# UNITED STATES PATENT AND TRADEMARK OFFICE

| APPLICATION NO. | FILING DATE | FIRST NAMED INVENTOR | ATTORNEY DOCKET NO. | CONFIRMATION NO. |
|-----------------|-------------|----------------------|---------------------|------------------|
| 10/647,877      | 08/25/2003  | Scott H. Carr        | 13976               | 3182             |

# Office Action Summary

CARR ET AL.

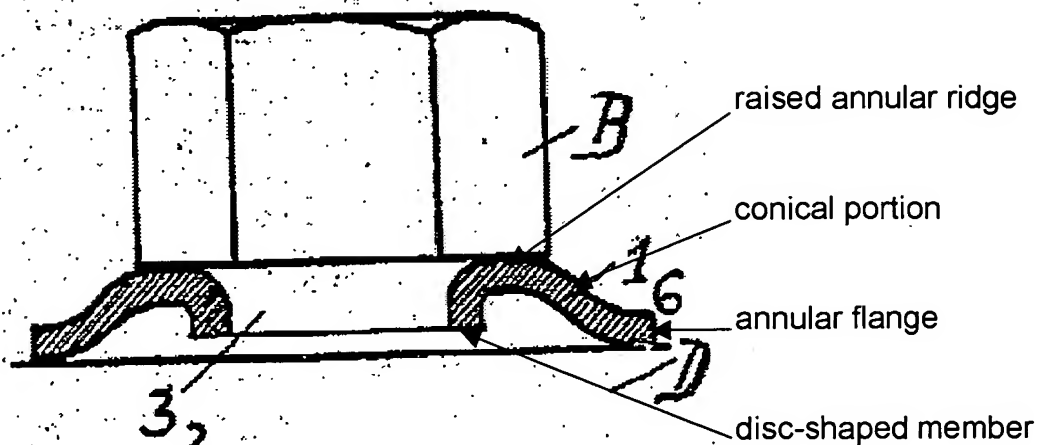
Claims 13 is rejected under 35 U.S.C. 102(b) as being anticipated by Märtens (US 1,320,259). In the embodiment of Fig. 6, Märtens discloses a washer comprising the portions as shown in the figure below wherein a "grounding screw" engages the ridge portion which would be capable of being tightened to urge the disc shaped portion into contact with a grounding terminal.
